CITY PLAN COMMISSION STAFF REPORT

Project Name
Emmanuel Science and Technology Center

Request
CD-CPC-2025-00037
Area Plan Amendment
CD-CPC-2025-00008
Rezoning without Plan
CD-CPC-2025-00004
Development Plan – Nonresidential

Development Plan Application Resubmittal 001
 Kansas City, MO: City Plan Commission
 02.14.2025

Emmanuel Science & Technology Center
 2418 Swope Parkway, Kansas City, MO 64130
LANDSCAPE PLAN

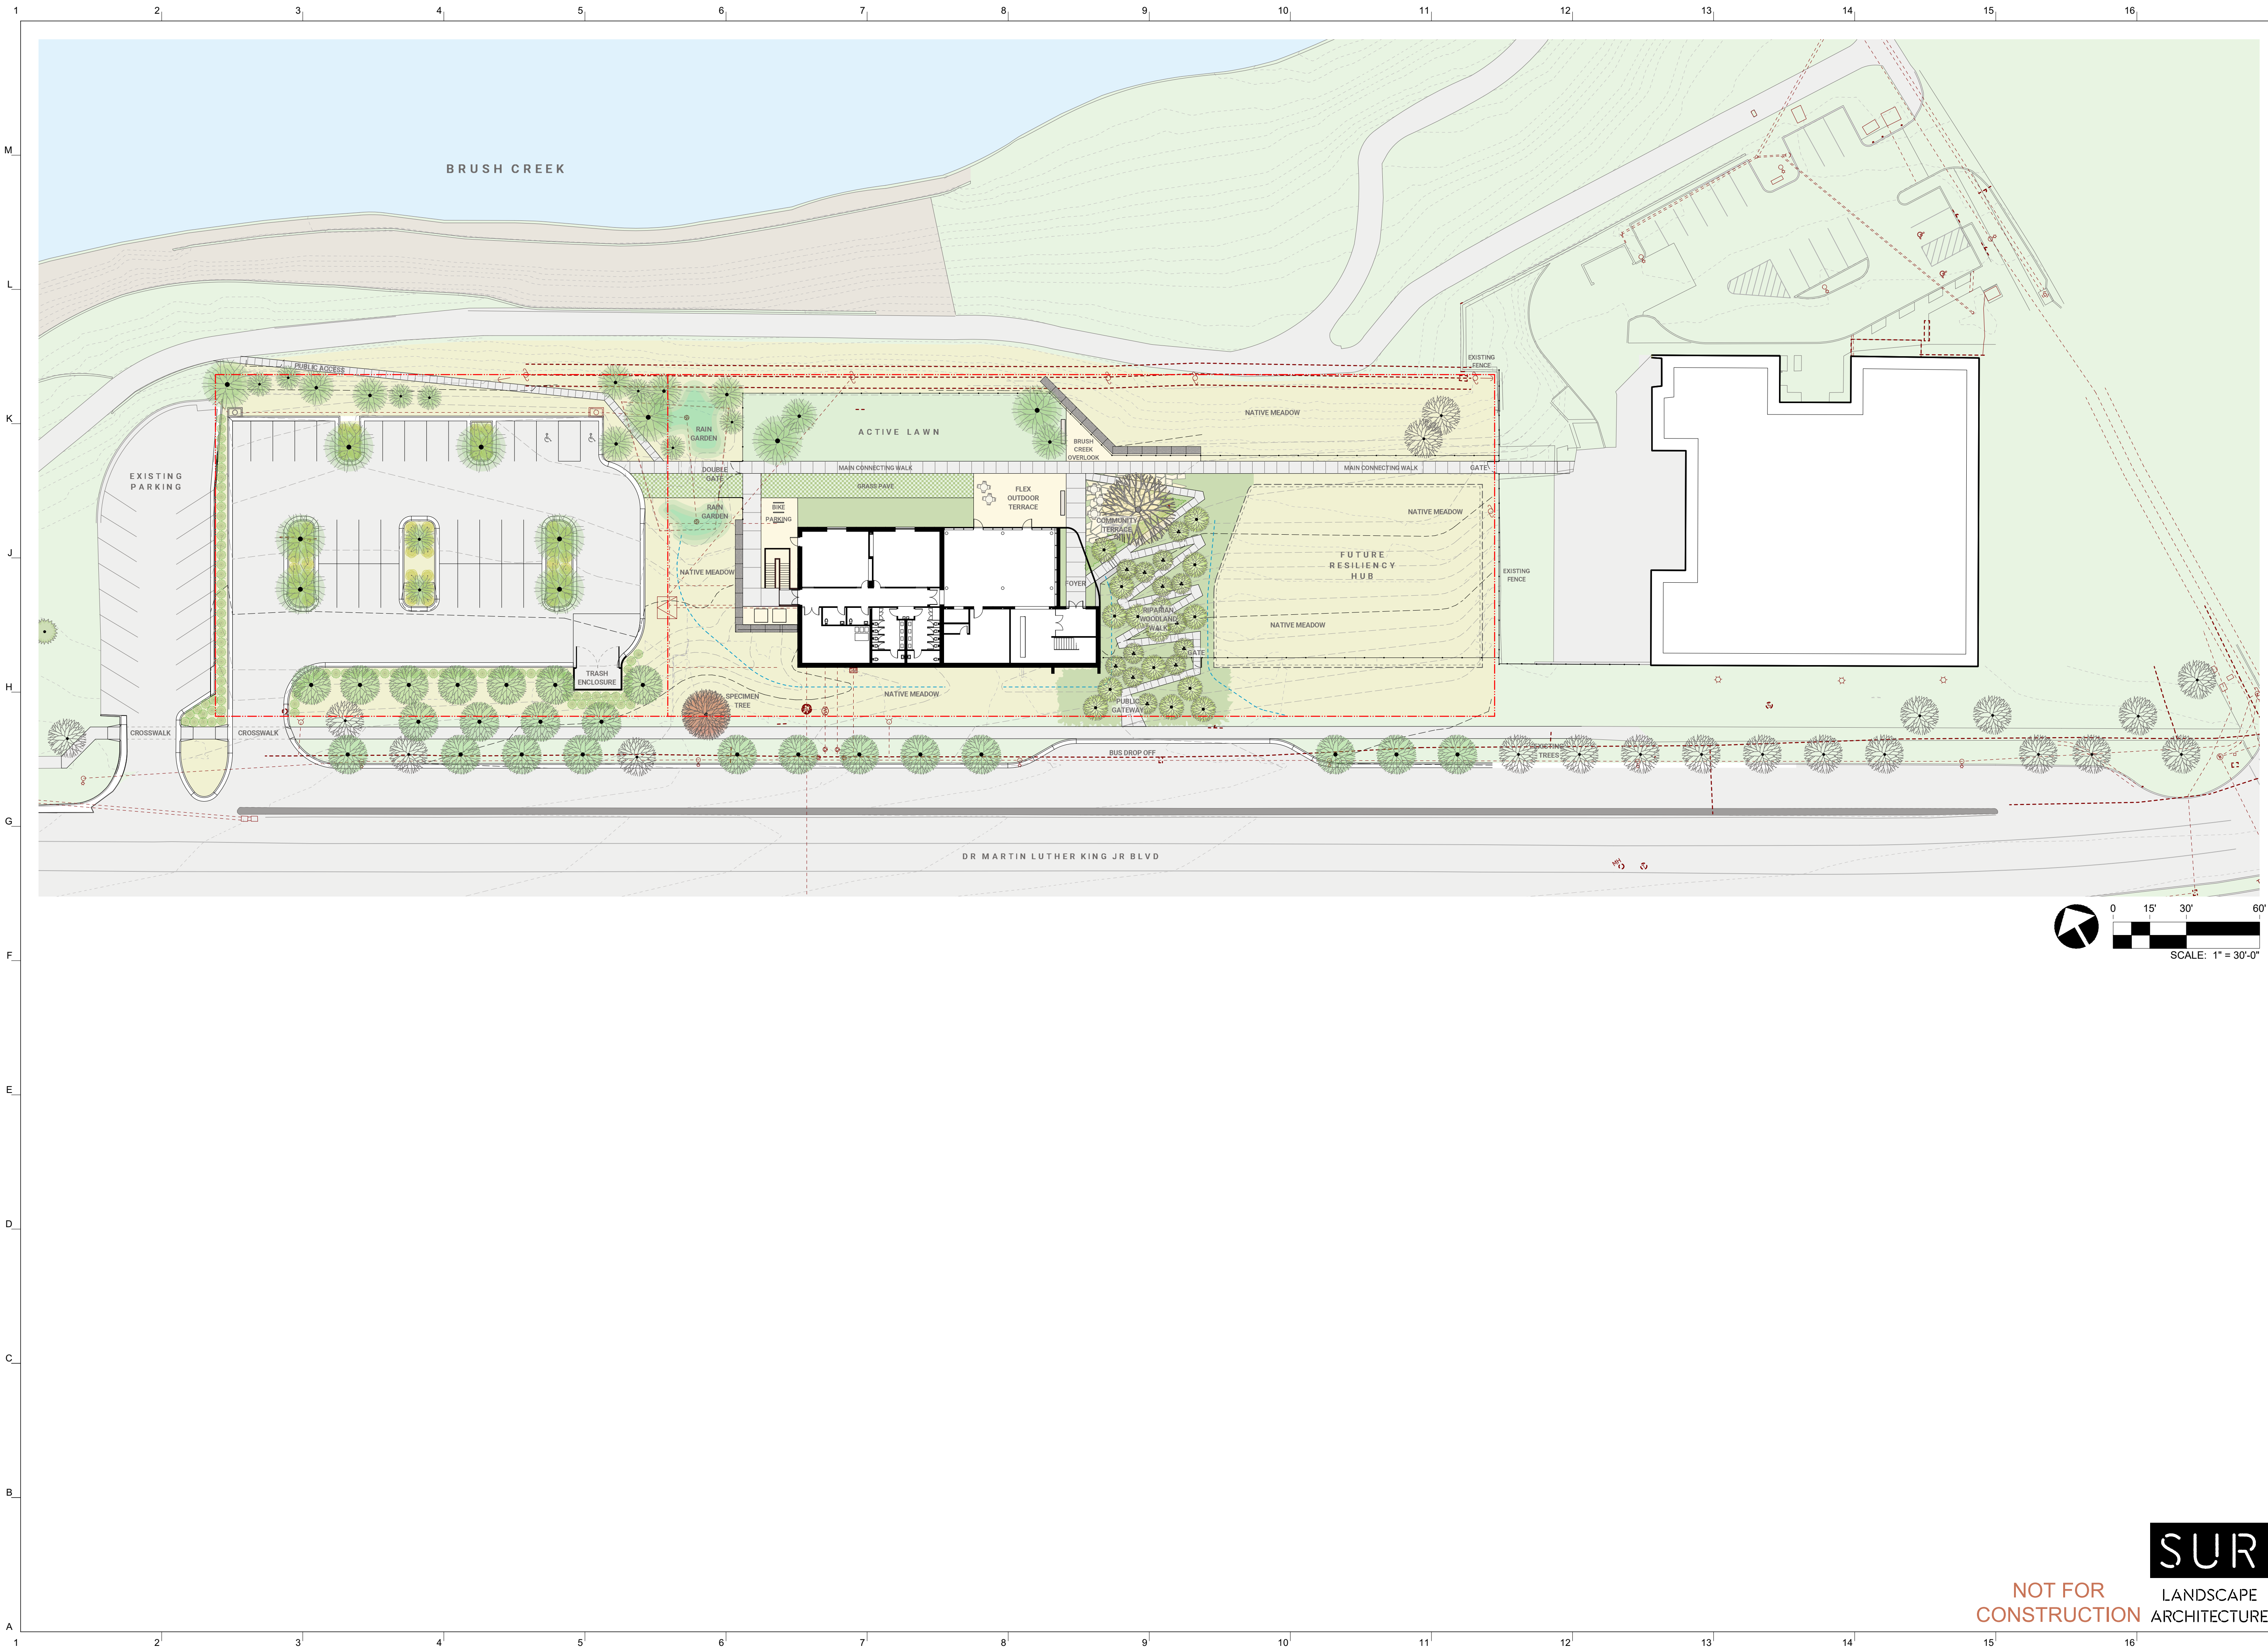
Variance 4 – A variance to 88-425-03-C. (1) – At least one street tree is required for each 30 feet of street frontage.

Proposed landscaping is currently not in conformance with the requirements as set forth in Section 88-425 of the Zoning and Development Code. The applicant will seek a variance to the required amount of street trees or revise plans prior to ordinance request.

1. That prior to issuance of the Certificate of Occupancy for each lot within the plat the developer shall submit an affidavit, completed by a landscape architect licensed in the State of Missouri, verifying that street trees have been installed in accordance with the approved Street Tree Planting Plan and are healthy.

6. All signage shall conform to 88-445 and shall require a sign permit prior to installation.
7. That prior to recording the Final Plat the developer shall upload and secure approval of a Street Tree Planting Plan from the City Forester.
